Proposed Development – 23 to 31 Dover Road, Rose Bay

Preliminary Assessment of Potential Geotechnical Impacts on Neighbouring Properties

Our ref: JM/C17038_Rev6

Reference/ Revision	Description	Date	Author	Reviewer
JM/C17038 Rev6	For comment – Geotechnical Assessment	1/12/2025	JM	MD

Plate 4-3: Graphical Representation of the Depth of Expected Groundwater Drawdown at Extending From the Excavation Boundary

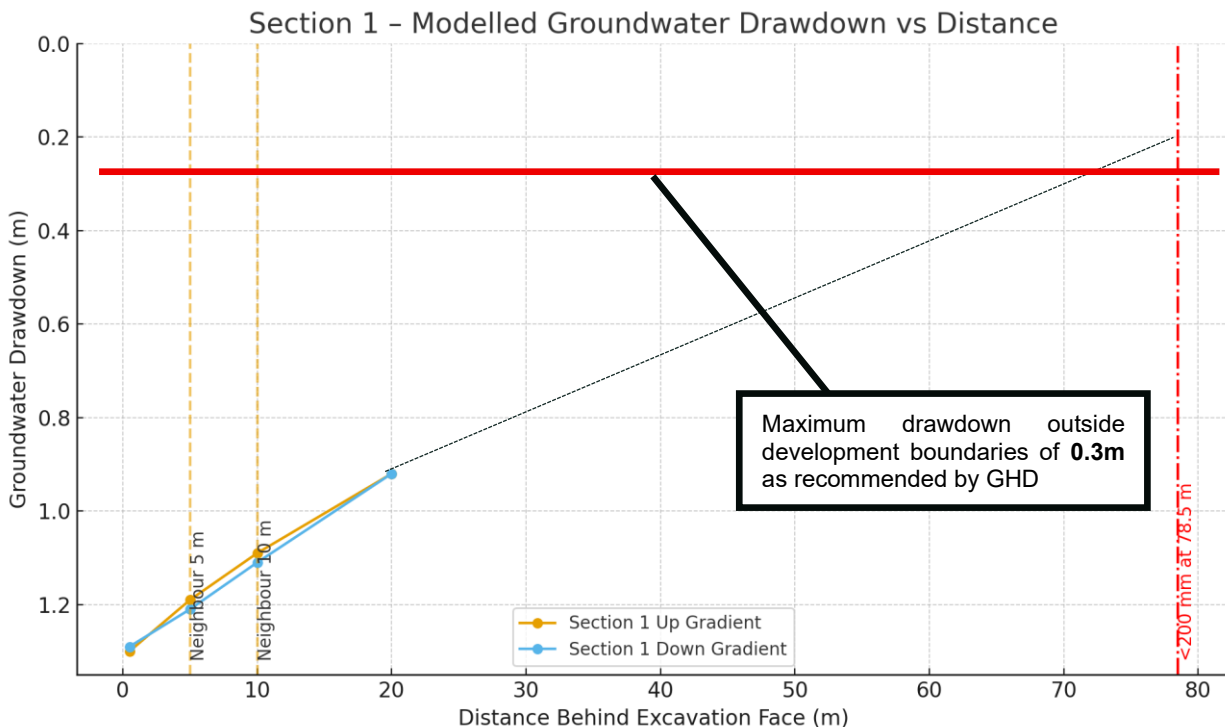
- The results of the groundwater drawdown modelling show that drawdown of the groundwater table is not just limited to the site, but exceeds 0.2m of drawdown extending up to 80m away from the excavation boundaries (and exceeding the GHD recommended value of 0.3m of drawdown up to ~75m away from the site boundaries). Therefore, the area impacted by groundwater drawdown exceeding the GHD recommendation is shown in the aerial photo in Plate 4-1 below, and impacts up to 40 properties.

- There are existing structures within 5m to 10m of the proposed excavation, and the modelling indicates that drawdown of the water table could be up to 1.3m depth at this set back distance. The GHD report commissioned by Woollahra Municipal Council states that such drawdown can cause settlement and damage to properties, and therefore recommended that **a limit of 0.3m of groundwater drawdown outside the development boundary**

be permissible. Given that the proponents modelling shows that groundwater drawdown will be greater than this affecting over 40 neighbouring properties, it is assessed that the proposed development does not comply with Council advice.

It is strongly recommended that the development be designed so that a maximum groundwater drawdown of 0.3m occurs outside the development boundaries. To monitor this (and all impacts) and to help prevent damage to existing neighbouring structures due to deep excavations, dewatering, and construction vibrations, it is recommended that geotechnical inspection and monitoring be carried out. It is imperative that these records be policed by Council (or an independently appointed geotechnical engineer or hydrogeologist) to ensure compliance.

Plate 4-4: Aerial Photo Showing the Approximate Area That will be Impacted by Groundwater Drawdown During Dewatering if All Proposed Developments Were to Proceed

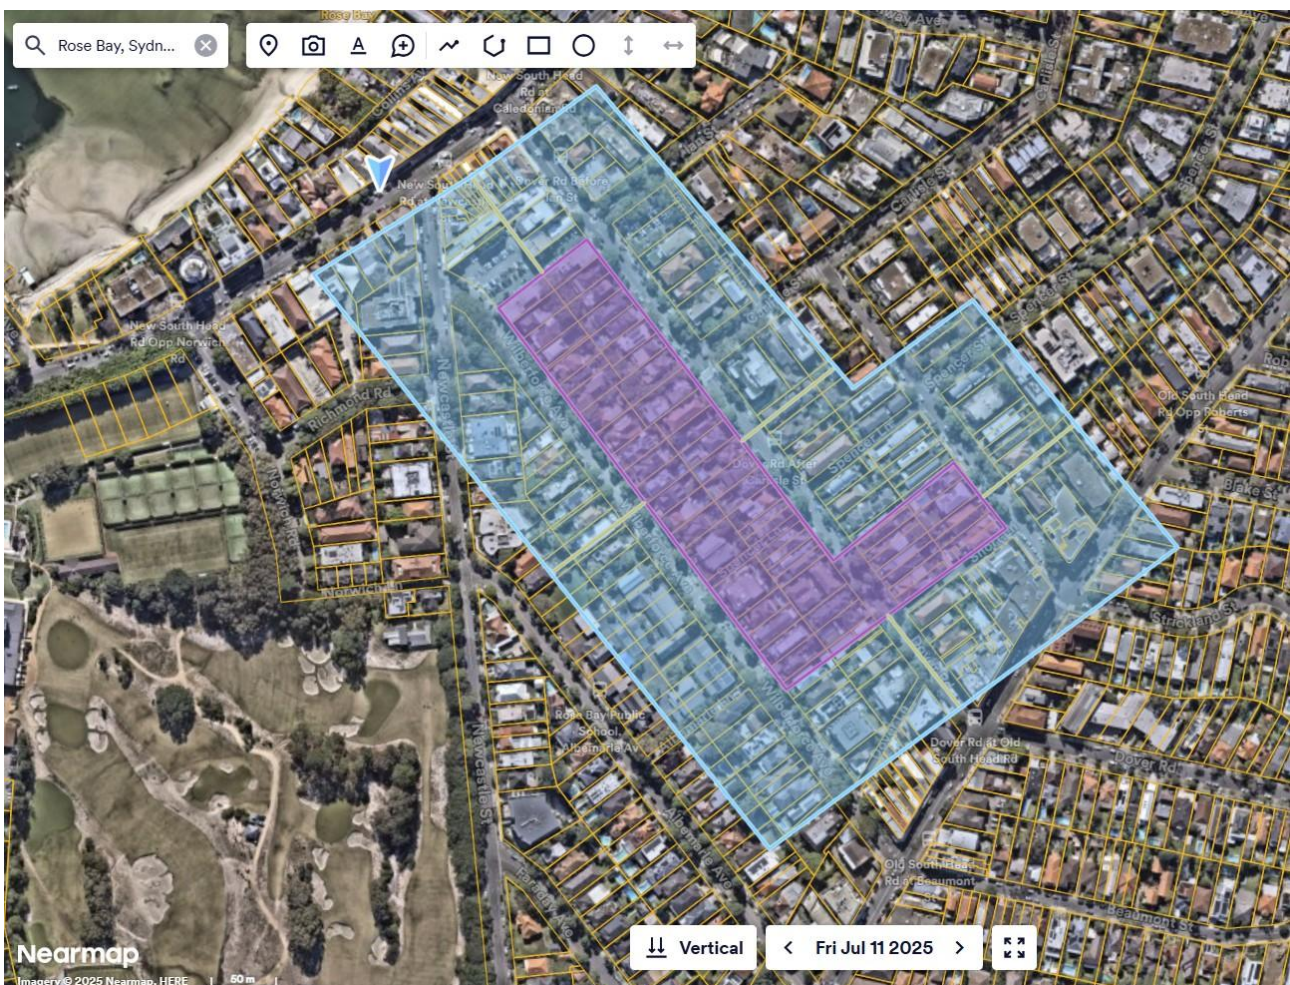
- It has been indicated that there are proposals for additional adjacent developments totalling an area of ~21,000m². Cumulative impacts where multiple basements are constructed in close proximity will vastly increase the groundwater drawdown and extend the area of impacted properties. It is estimated that up to 130 neighbouring properties could be impacted if all proposed developments proceed. The approximate area which could potentially be impacted by groundwater drawdown if the additional development proceed is shown in the aerial photo in Plate 4-4 below, showing impact to up to 130 properties. It should be noted as this is approximate and would depend on what properties were being dewatered at particular times, and the exact level of groundwater drawdown. This is just to provide an indication of the significant area which could potentially be impacted.

- It has been indicated that there are proposals for additional adjacent developments totalling an area of ~18,500m² to 21,000m². Cumulative impacts where multiple basements are constructed in close proximity will vastly increase the groundwater drawdown and extend the area of impacted properties. It is estimated that up to 130 neighbouring properties could be impacted if all proposed developments proceed.

Plate 5-1 – Indicative markup provided by the client showing the development site (yellow), proposed LMR development sites (red), and known properties that have experience structural damage due to adjacent developments.

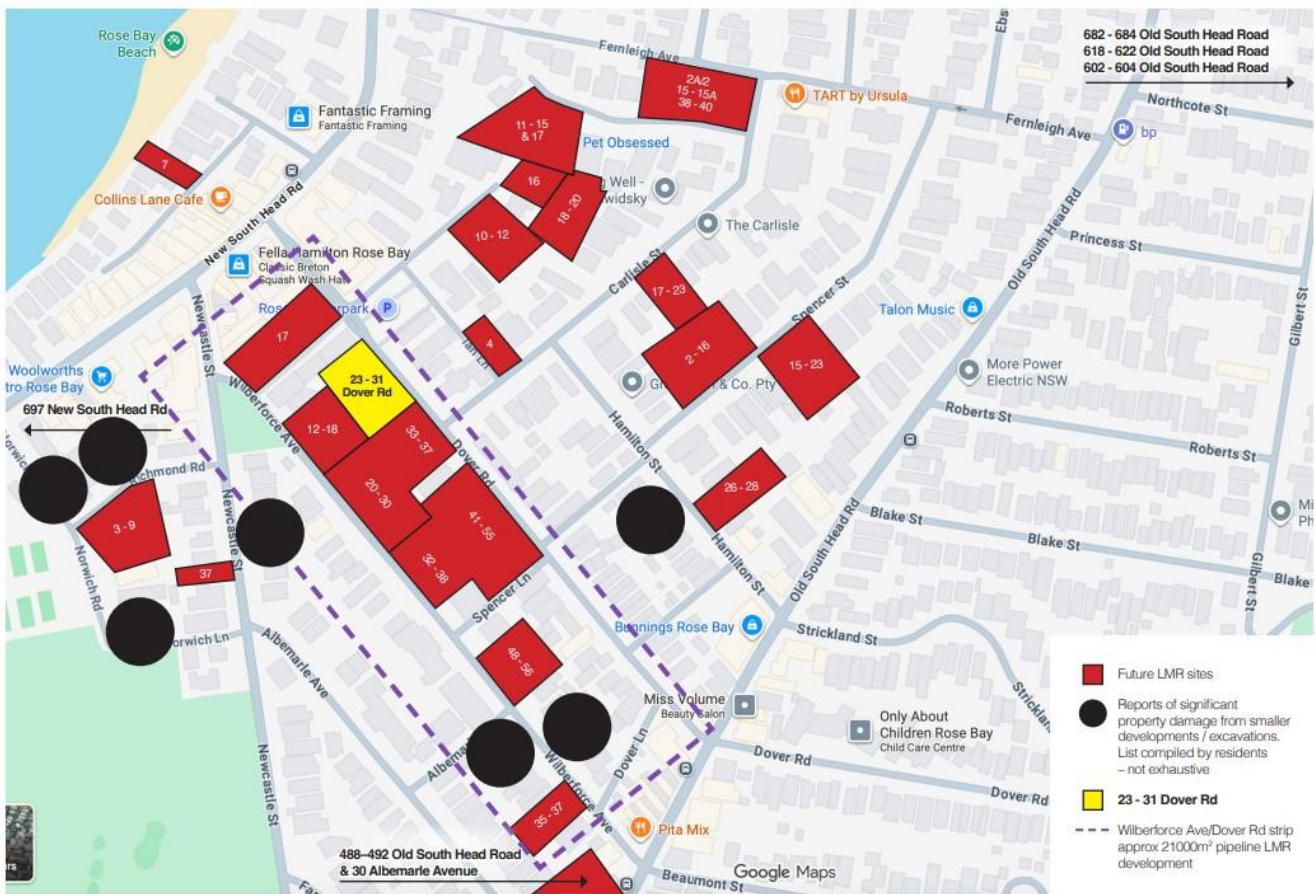
- Numerous instances in Double Bay and Rose Bay of structural cracking and damage to existing houses and apartments which are located near or adjacent to building sites where deep excavations with dewatering are being undertaken. Specific instances where structural damage to neighbouring properties that have been attributed to shoring installation (both from vibrations due to installation of sheet piling and over-flighting for bored piles), excavation and dewatering works in Rose Bay are shown in Plate 5-1 and include:

- o Norwich Lane – back wall came away from the neighbouring house
 - o Richmond Avenue – structural cracks appeared in block of neighbouring units (stop work issued).

- o Wilberforce Avenue – neighbouring house collapsed. The house was deemed unsafe for occupancy and it was subsequently sold and demolished.
 - o Wilberforce Avenue – the same above development caused flooding into the basement of a neighbouring house.
